PRODUCT UPDATE

July 19, 2018

#201

1B/1K/1T/1W.801 and 803 Coaxial Contact Assembly Tool

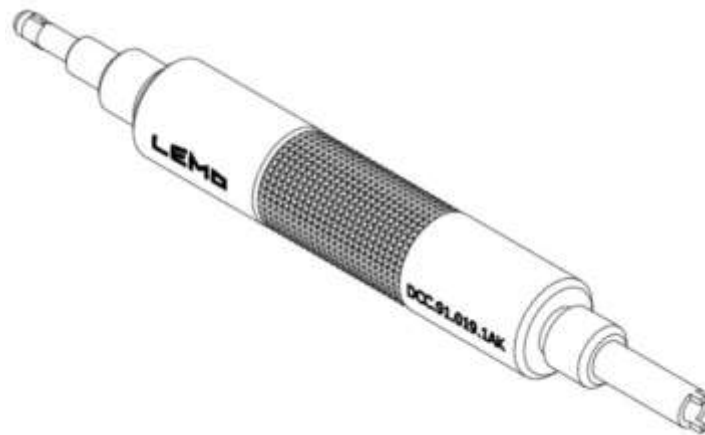
The design of the coaxial contact assembly tool used in the 1B,1K, 1T and 1W Series (with 801 and 803 type inserts) has been updated.

The assembly tool for the type F male and female coaxial contact has changed. It has a new outer shape and is black chrome-plated Steel rather than the blue anodized Aluminum.

The tool part number has changed from DCC.91.019.1LA to **DCC.91.019.1AK**.
